Generic Swing Space at LEL West Tower

ELECTRICAL:
19TH FLOOR - LIGHTING
AND FIRE ALARM

E-4
N° du dessin

1 19TH FLOOR – LIGHTING AND FIRE ALARM
E-4 1:100

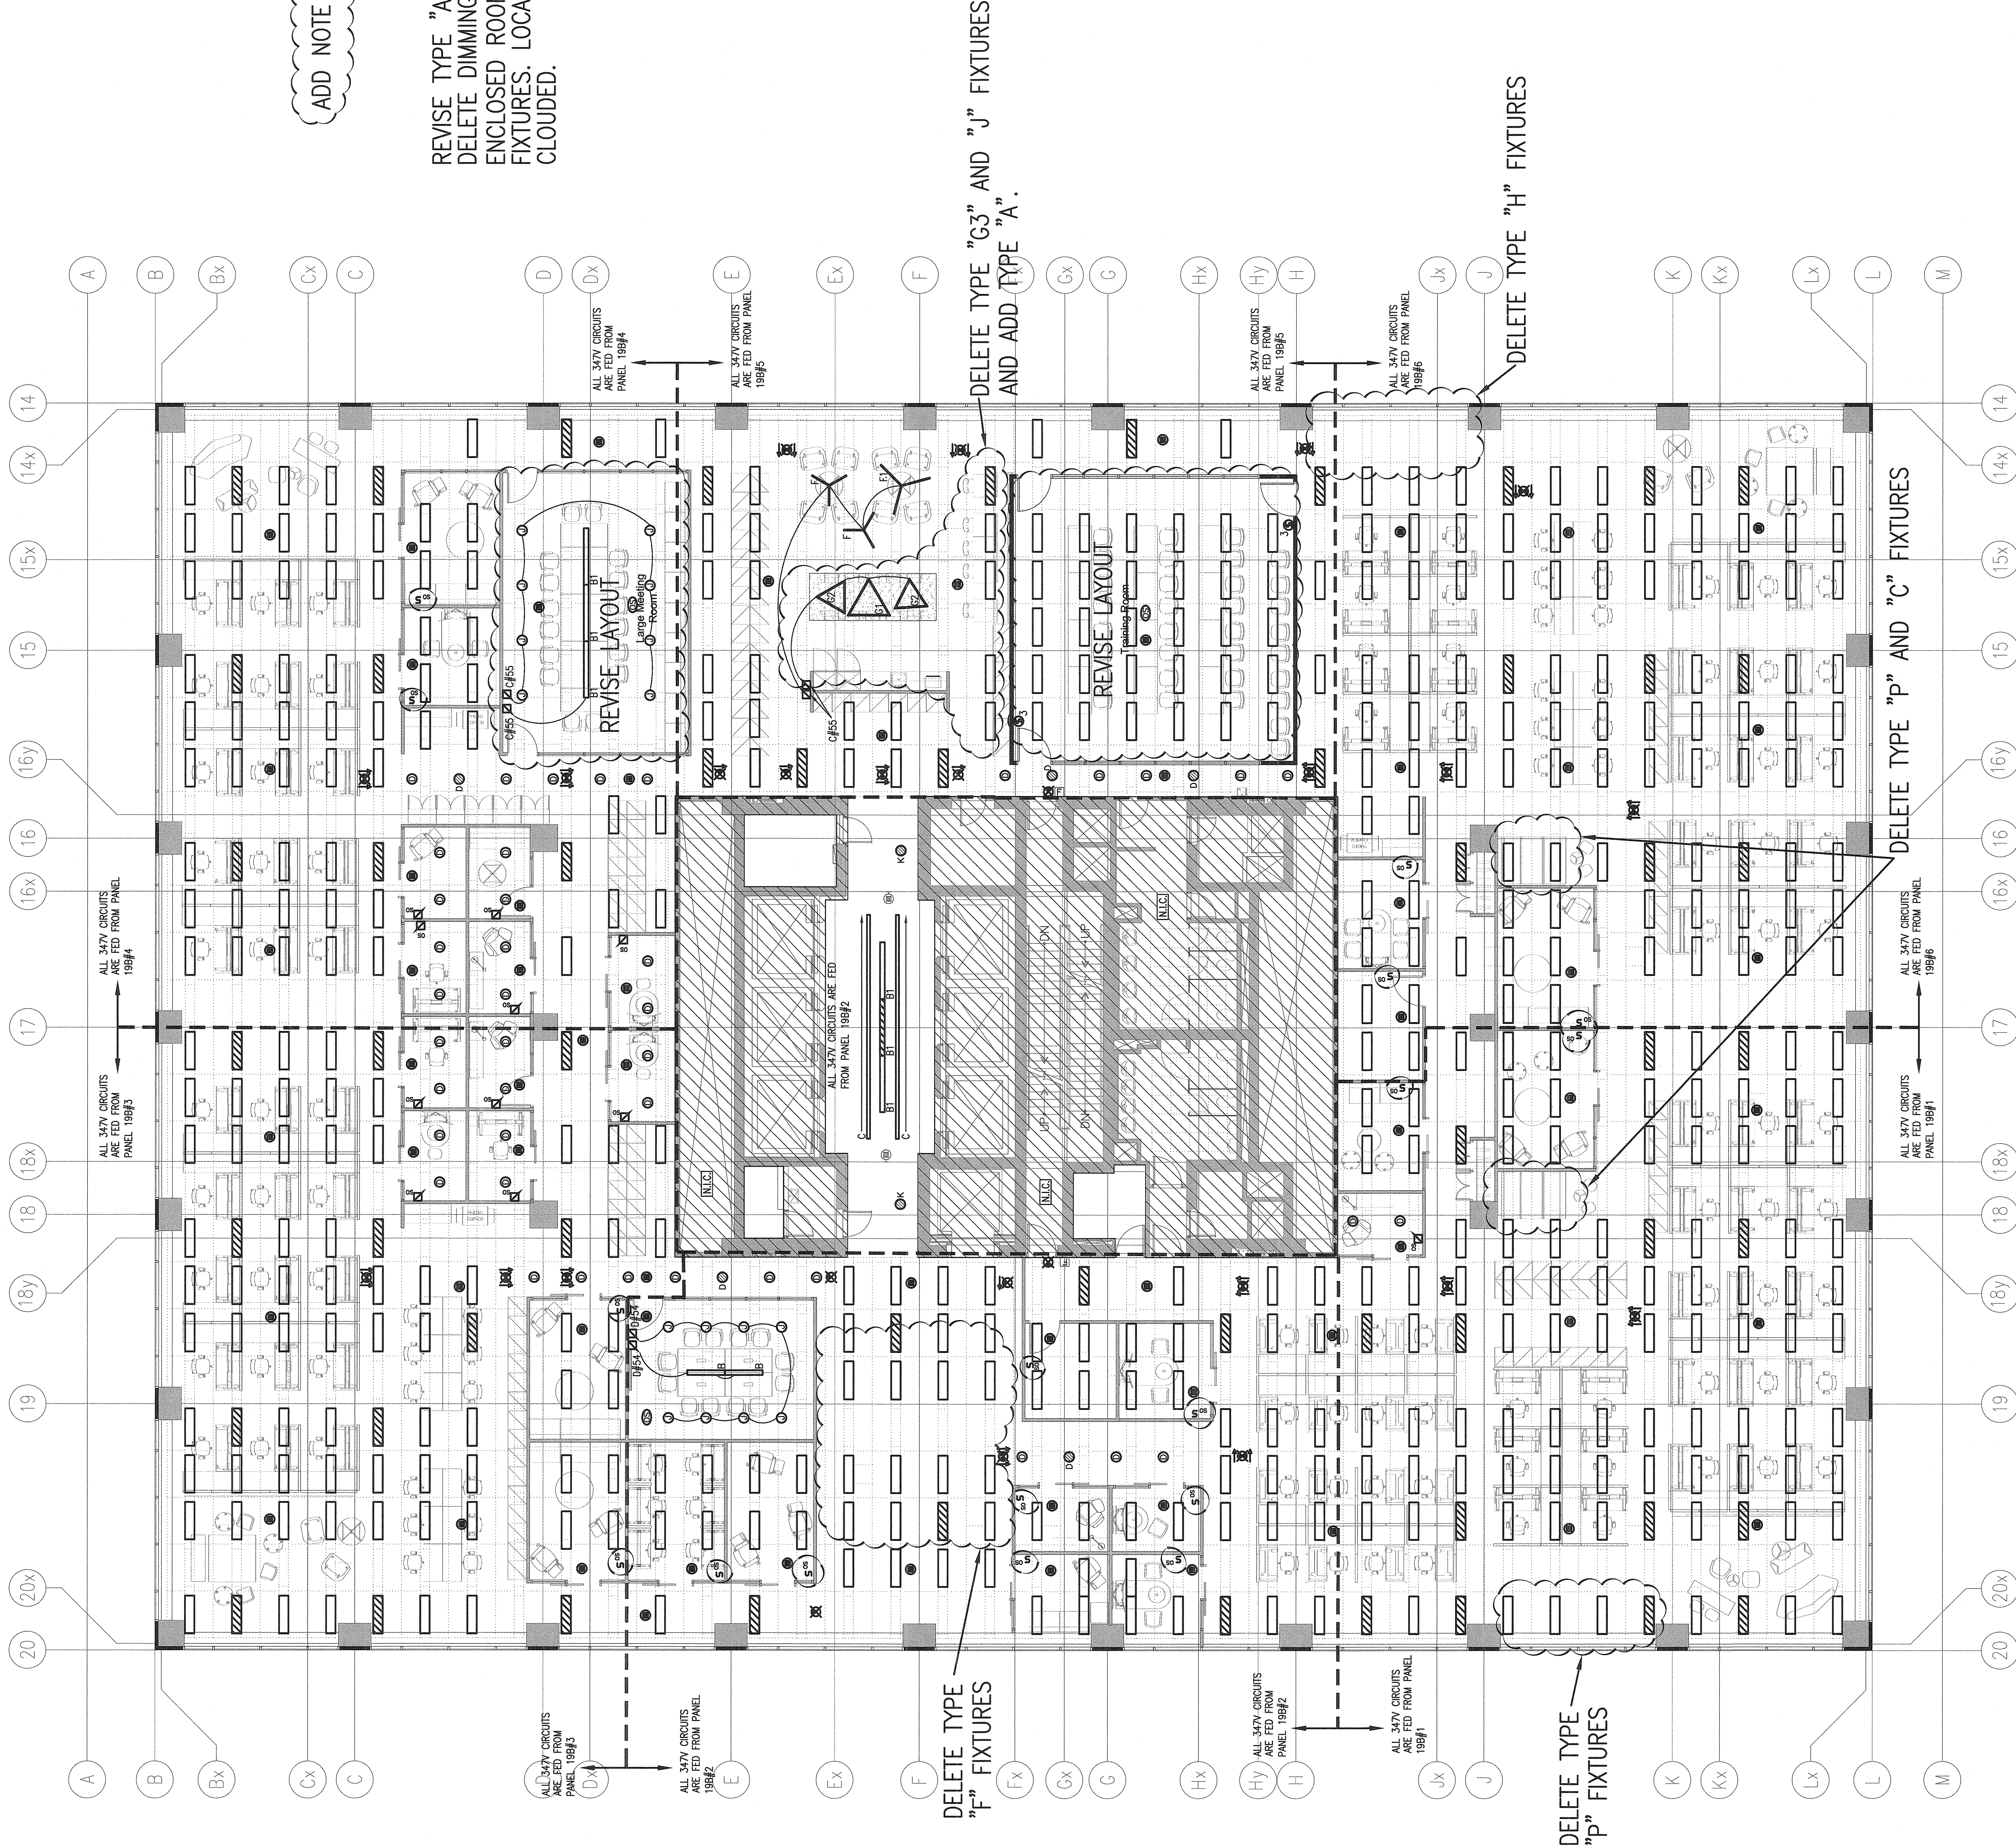
ADD NOTE

REVISE TYPE "A" LIGHTING LAYOUT.
DELETE DIMMING FEATURE FROM
ENCLOSED ROOMS WITH TYPE "A"
FIXTURES. LOCATIONS ARE SHOWN
CLOUDED.
